Generic Design Assessment – New Civil Reactor Build
Step 4 Human Factors Assessment of the Westinghouse AP1000® Reactor

Assessment Report: ONR-GDA-AR-11-012
Revision 0
11 November 2011

Figure 2: Critical Safety Function Display for Sub-criticality

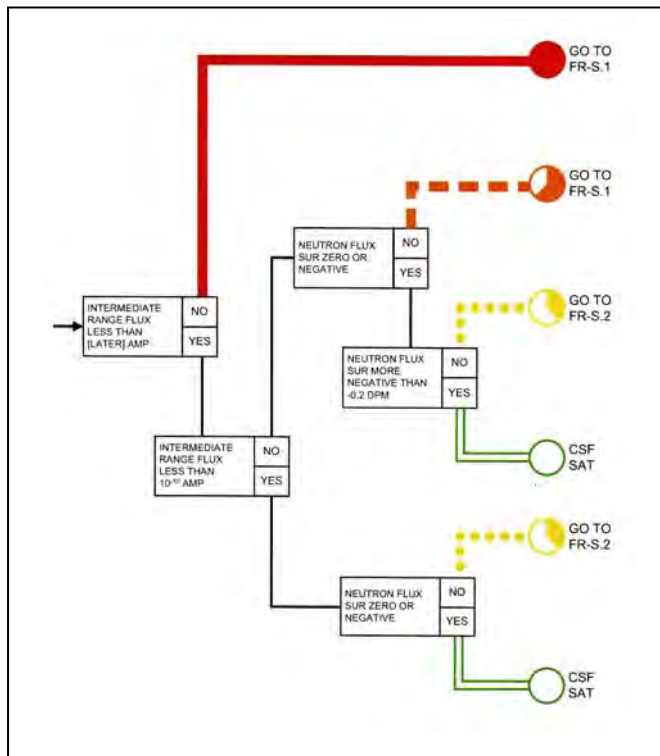
687 In general I consider that the CPS presentation of procedures generally meet relevant criteria, although I note issues relating to place keeping.

688 Apart from my principal concern relating to the use of system designators, the paper-based procedures meet my criteria for the level of detail provided and the wording of instructions, although in other respects they were poor. In particular, I did not consider that the procedures were presented in a way that would assist operators to develop effective mental models of their tasks, which increases the potential that actions may be undertaken by rote, rather than by understanding. Regarding place keeping and reducing the potential of omitting steps, I considered that the printed procedures were acceptable, but that there was room for improvement. I consider that Westinghouse's proposal that the operators will mark paper copies of the procedures as a place keeping check is completely inadequate.

AF-AP1000-HF-84 - *The licensee shall provide and justify a place keeping system / methodology for procedural use that does not rely on operators marking up paper copies of computerised procedures.*
